Re: Nine Mile Point Unit 1
Docket No. 50-220

Your letter dated March 4, 1977 requested additional information concerning the reload application for Cycle 5 operation of Nine Mile Point Unit 1. The enclosed information addresses itself to the attachment to your letter.

RESPONSES TO MARCH 4, 1977

NUCLEAR REGULATORY COMMISSION QUESTIONS

Figure 6-12. Nine Mile Point-1 Rod Block Response to Control Rod Motion for Rod Withdrawal Error - Limiting Case, Channel A+C for Reload-6

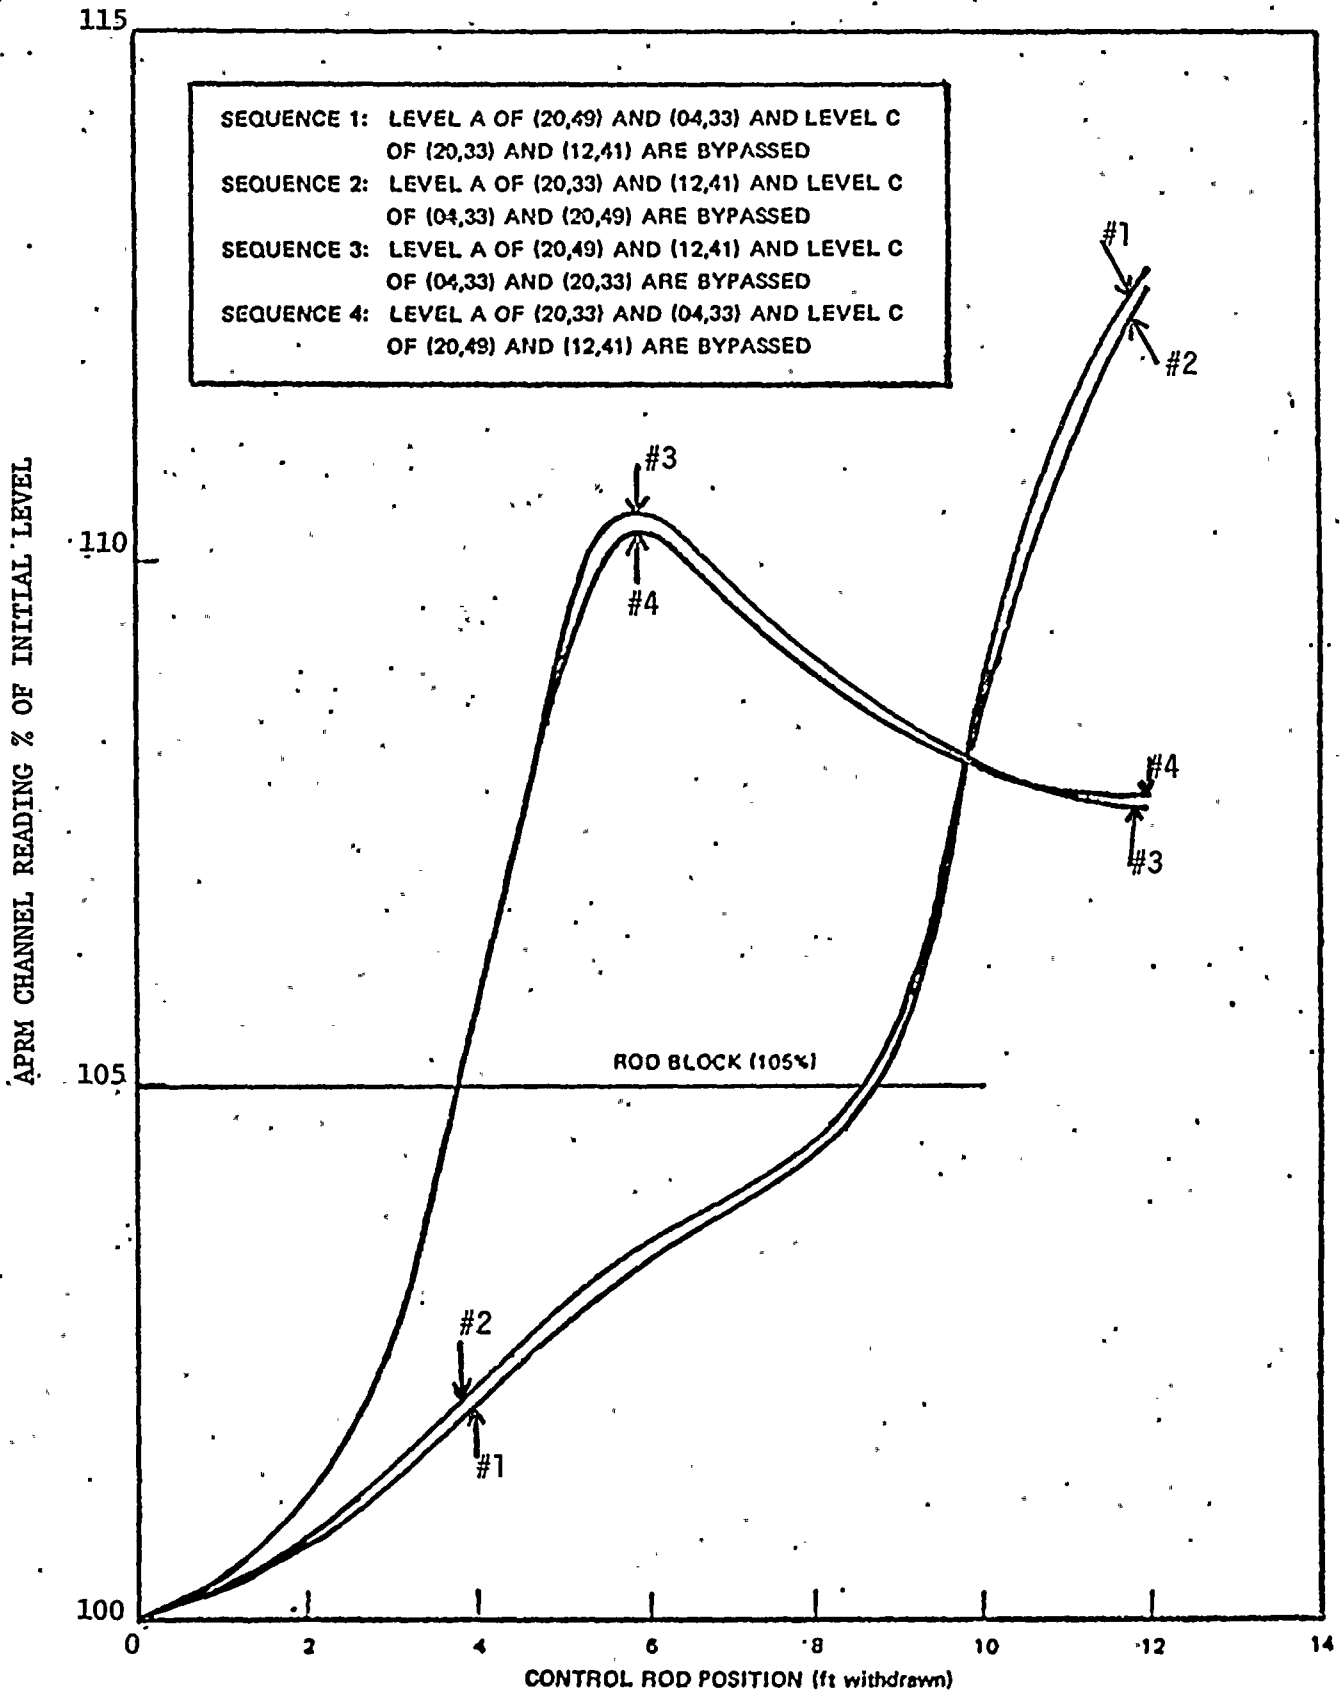
Please provide corrected versions of Figures 6-12 and 6-13. The sequence numbers of the plotted curves are not identified, and the Rod Block Line (identified as being at 105%) is plotted at 102.5%.

The "Rod Block 105%" line was incorrectly drawn on Figures 6-12 and 6-13. The corrected figures are attached.
